Access Compliance Report

Public Rights-of-Way

(Pedestrian Signals)

Intersection ID: N/A	Main Street:	Cross Street: N/A	Location: N/A
ADA ID: 3D60D8834183	Signal Type: Two Push Buttons-Non APS	Overall Compliance: No	Severity Score: BTN 1:N/A BTN 2: N/A No BTN: N/A
Codes/Mitigation Info/Possible Solution		Field Measurements/Component Compliance

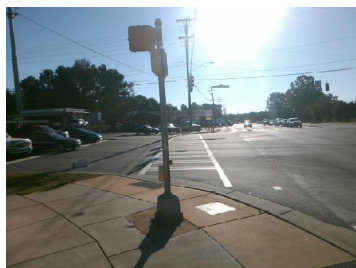
PROW/ADA: TMUTCD 4e.08, R404.2, R406.2

Yes	B 1 Clear Xing Direction?	ClearlyMarked	Yes	B 2 Clear Xing Direction?	ClearlyMarked
	B 1 Crossing Direction	To S		B 2 Crossing Direction	To SE
Yes	B 1 DistanceTo XWalk (in)	59.0	Yes	B 2 DistanceTo XWalk (in)	0.0
No	B 1 DistanceTo Curb (in)	100.0	No	B 2 DistanceTo Curb (in)	88.0
Yes	B 1 Diameter (in)	2.0	Yes	B 2 Diameter (in)	2.0

Possible Solutions: Replace Signal Push Button With APS Button on New Post. Remove & Relocate Sign.
